<b>ADDRESSEES</b>	: ABC Customer Care and Parts Source Owners and operators of coaches listed under 'Application'
<b>VEHICLE MODEL</b>	: CX45, TX40, TX45
<b>SYSTEM/SUBSYSTEM</b>	: 14.10 Electrical system – Switches
<b>BULLETIN TYPE</b>	: Product Improvement
<b>DATE</b>	: September 09th, 2015
<b>SUBJECT</b>	: <b>Protection of control panel switches in engine compartment</b>
<b>TERMS &amp; CONDITIONS</b>	: No reimbursement will be awarded for carrying out this product improvement.

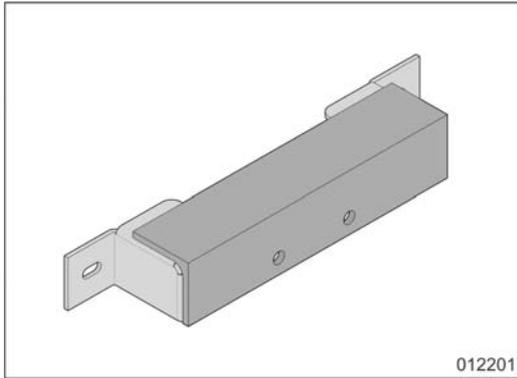
As from following units, Van Hool have moved the control panel in the engine compartment from upon to beside the toilet service door (refer to figures 1 and 2).

1. Service records have shown that in the previous design the lower switches of the control panel are subject to damage when someone tries to close the rear engine compartment door while the toilet service door is still open.
2. To address this issue, installation of a guard is necessary on vehicles with the control panel upon the toilet service door.
3. Please refer to the material list and step-by-step instructions from the procedure below if you want to install this guard.
